THE CHEYENNE HERALD

November 29, 2007 ♦ Issue No. 136 ♦ Next issue December 13, 2007

Downtown Skywalk in violation of Code?

Skywalk to Hynds Building – north view, down the alley north of Hynds

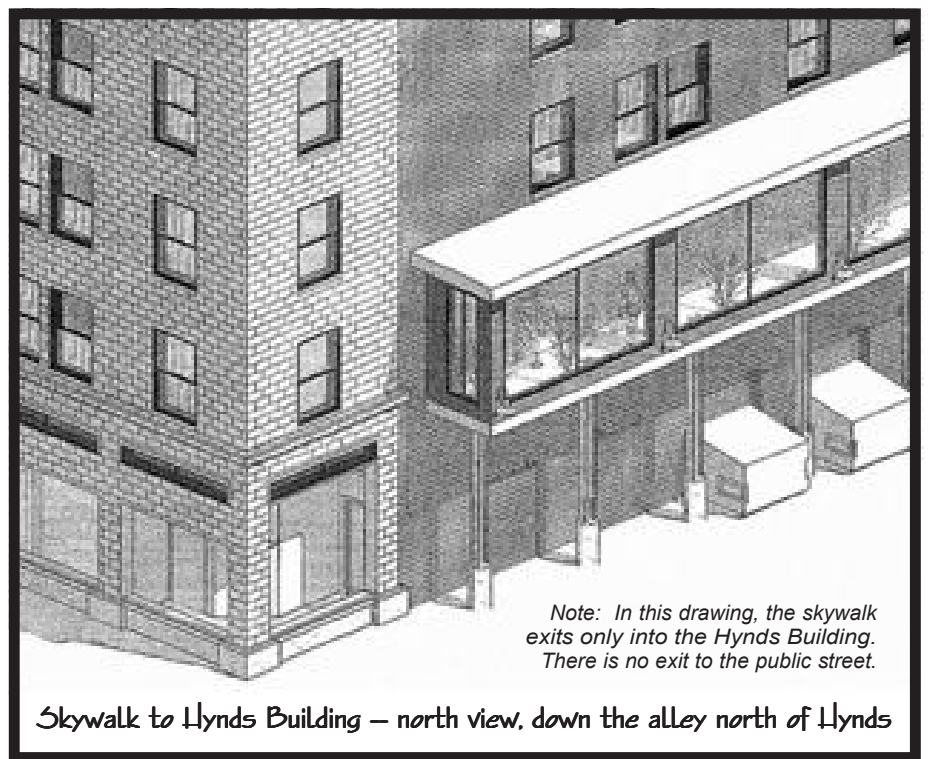
You can see from the drawing above that the planned elevated tunnel is just a little wider than a traveler needs to pull his Samsonite behind him from the car to the room in the yet-to-be delivered Marriott.

The drawing of a proposed skywalk running from the parking garage down the alley between the Hynds Building and buildings like Phoenix Books & Music and ending at Capitol Avenue shows a width of 12' between the walls of the buildings - the alley's total width.

At the height of a little less than 11', the skywalk extends into the alley more than 5' at the bottom and 6' or so at the top, which is about 23' from the ground.

This block long alley, one would think, should be accessible to ladder fire trucks and trash pickup vehicles. The maneuverability of a ladder truck would be greatly restricted with an alley opening of less than 7' the full length at 11' height.

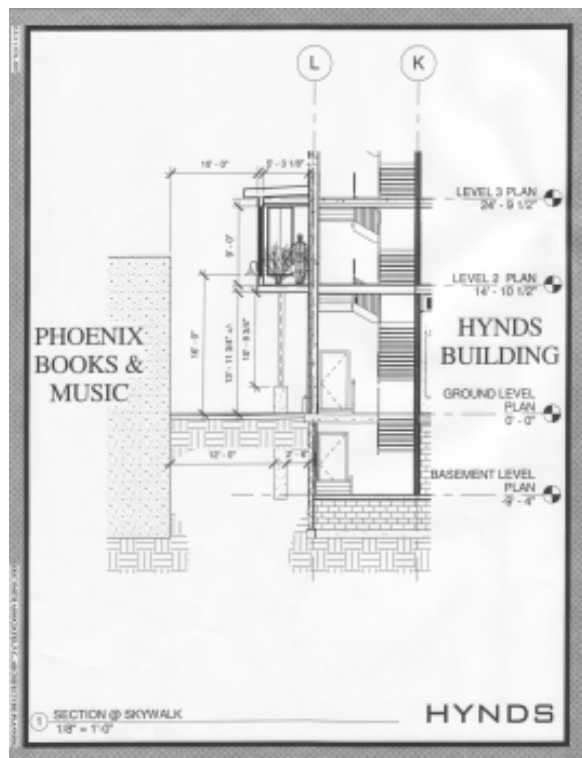
While the drawing at lower left may be a little hard to decipher, the clearance to the lower deck of the skyway is 10' 9 3/4". That is ten feet, nine and three quarters inches.

According to **Section 3202.3.4 Pedestrian walkways** (in the 2003 IBC book), "The installation of a pedestrian walkway over a public right-of-way shall be subject to the approval of local authority having jurisdiction. The vertical clearance from the public right-of-way to the lowest part of a pedestrian walkway shall be 15 feet (4572 mm) minimum.

To reach that minimum would require raising the elevated walkway four feet, two and a quarter inches. That would leave

The first would be to raise the enclosure enough to obstruct the windows in the buildings (especially the Hynds, which is shown). The second would be to lower the nine (9) foot height of the skyway to a little less than five (5) feet. That probably wouldn't be approved.
